**APPENDIX M-2**  
**Viewshed Analysis for Facilities Associated with the Gulf XPress Project**

**Gulf XPress Project  
Docket No. CP16-361-000**

**VISUAL IMPACT ASSESSMENT  
FOR THE  
MOREHEAD, PAINT LICK, AND CANE RIDGE COMPRESSOR STATIONS**

**RESPONSE TO AUGUST 24, 2016  
ENVIRONMENTAL DATA REQUEST 17  
NOVEMBER 3, 2016  
3, 2016**

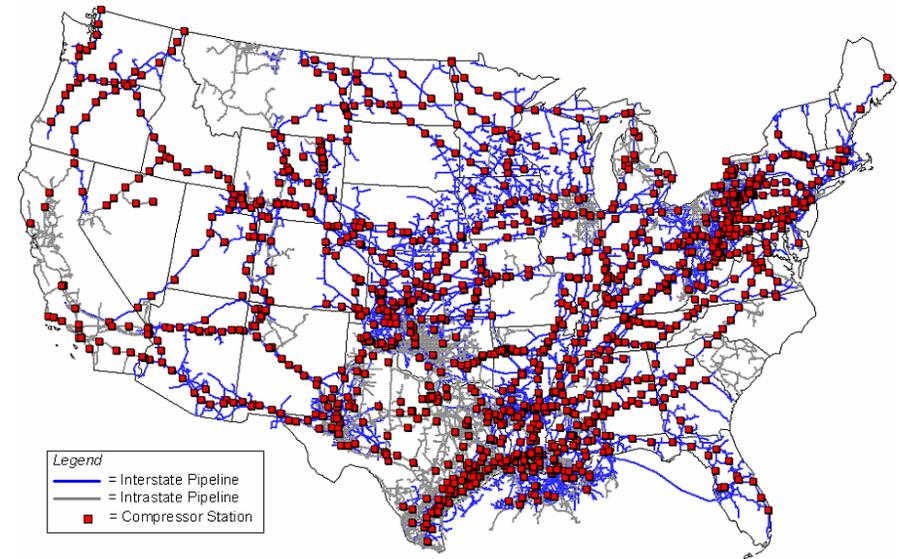
The U.S. Energy Information Administration map below illustrates the location of natural gas compressor stations in the United States, many of which are located in metropolitan areas.

LA001-5: See response to comment IND017-9.

Figure 1. Unconventional Wells Drilled in Ohio, Pennsylvania, and West Virginia (2004-2015).<sup>76</sup>

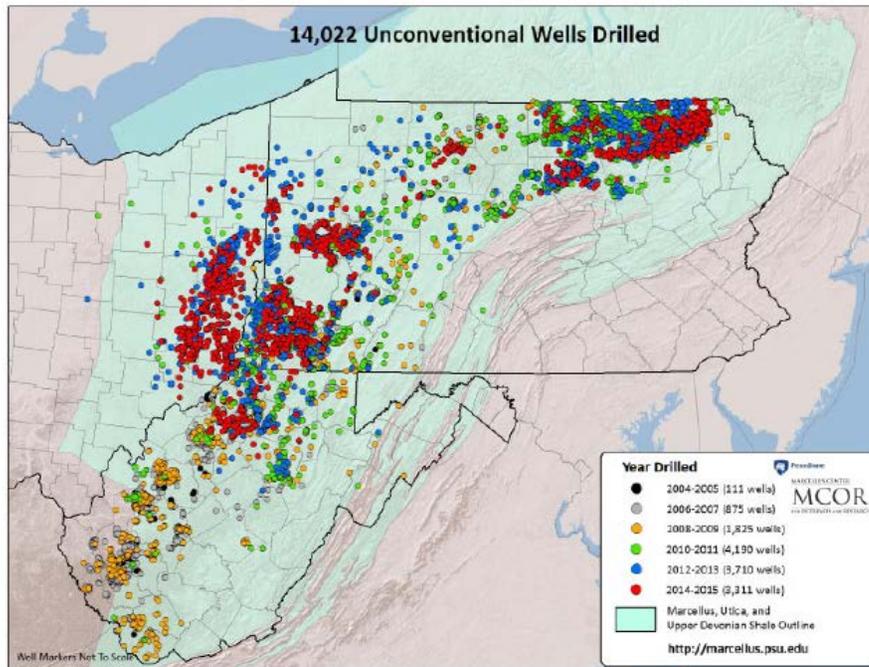
Moreover, FERC excluded the impacts of oil and gas production from its cumulative impacts analysis. FERC excluded these impacts despite “recognize[ing] that oil and natural gas exploration and production activities are *ubiquitous* in many of the counties crossed by the MXP” and involve similar construction methods that cause “erosion and sedimentation, and impacts on wetlands, waterbodies, and other natural resources.” DEIS at 4-320 (emphasis added). The “ubiquitous” nature of shale gas production is evident in Figure 1.

**Figure 2: Total Confirmed Bobcat Observations, 2006-2011.**

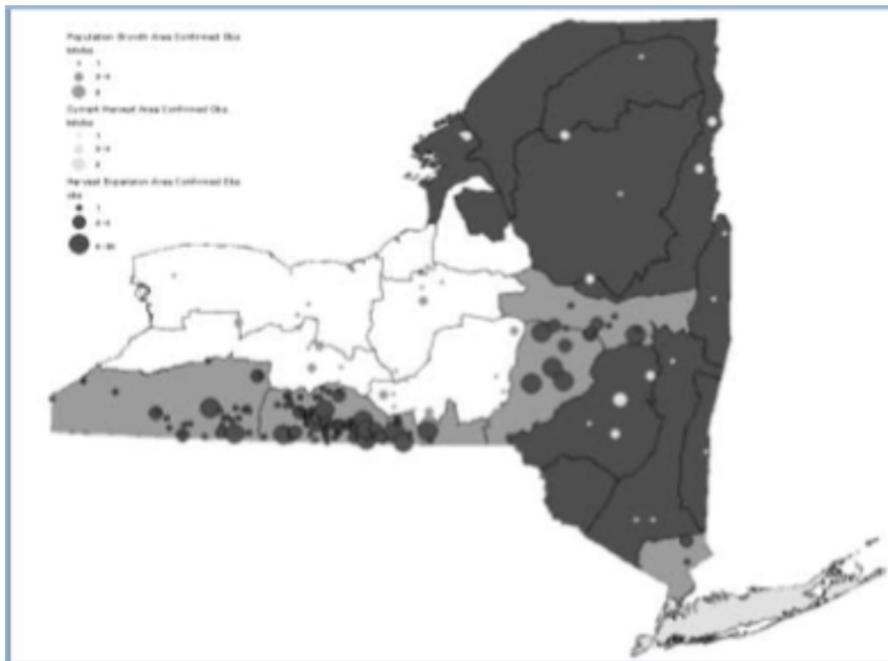
While NYDEC was documenting an increase in bobcat observations in the southern tier of New York between 2006-2011, hundreds and then thousands of shale gas wells were being drilled in the northern tier of Pennsylvania. *See* Figure 2 above. As Figure 2 indicates, between 2006-2011, gas companies drilled at least 4,858 shale gas wells in Pennsylvania. Many of these wells were drilled in Pennsylvania's northern tier. Thus, at the same time the gas industry began and then rapidly escalated gas drilling across the northern tier of Pennsylvania, the bobcat population in the southern tier of New York "increased dramatically." Since there has been no shale gas development in New York throughout this time period due to a moratorium (and now ban)<sup>79</sup> on

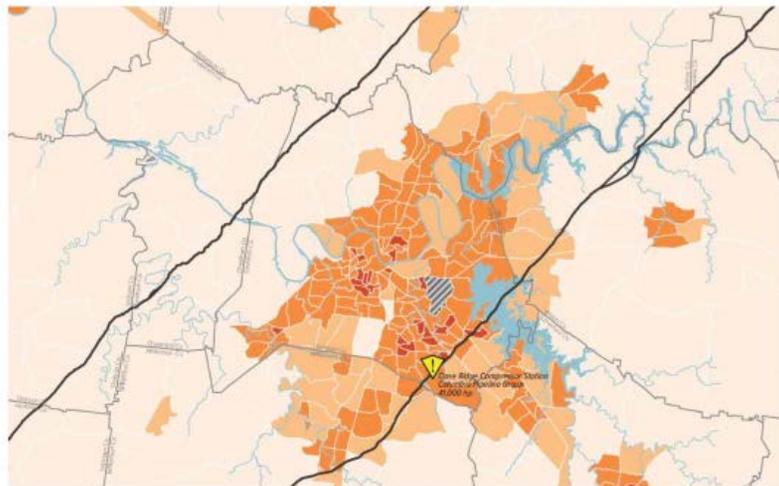
CO012-4  
(cont.)

**CO012-4:** Demographic information provided by the commentor is noted. Environmental justice considerations associated with the GXP are discussed in section 4.9.9.2.

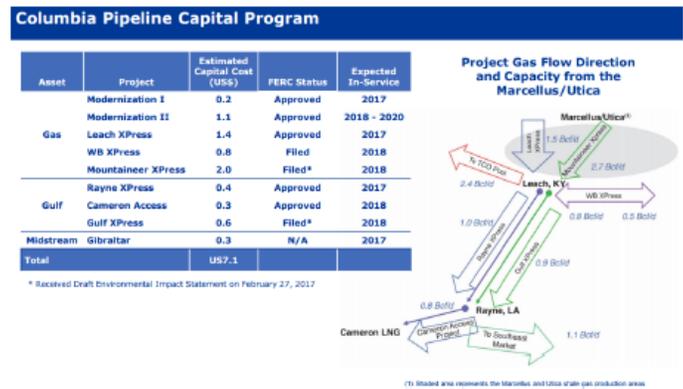
The DEIS does not establish a public benefit for the Project or Compressor Station. Section 1.1.2 of the DEIS describes the purpose of the Project to expand the capacity of TransCanada’s existing system to allow for an additional 860,000 Dth/d of natural gas delivery to high-demand southern markets in Mississippi and Louisiana.<sup>20</sup> The only information about where the natural gas will be shipped appears to be the statement in the DEIS informing the public that TransCanada has executed four agreements with shippers to identified receipt points.<sup>21</sup> Additional information available on TransCanada’s website suggests that the Project may be designed for the export market:

**CO012-7:** The Council on Environmental Quality’s NEPA regulations require the Commission to “briefly specify the underlying purpose and need to which the agency is responding in proposing the alternatives including the proposed action.” (40 CFR 1502.13). The draft EIS includes an appropriate purpose and need statement in section 1.1.2 in compliance with NEPA. The Commission’s decision on whether to authorize the GXP will be based on an evaluation under the Certificate Policy Statement of whether there is a need for the project and if it will serve the public interest. In balancing the public benefits against the potential adverse consequences, this evaluation considers many factors, including but not limited to impacts to landowners and communities affected by the construction.

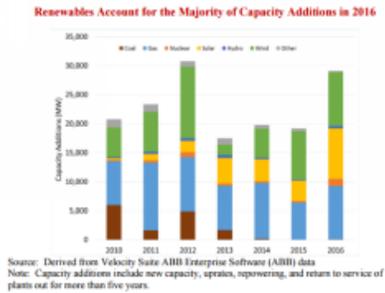
In April 2017, the Commission also conceded that production for natural gas declined in 2016, that electricity demand has been stagnant for a decade, and that the largest increases of capacity are coming from renewables:
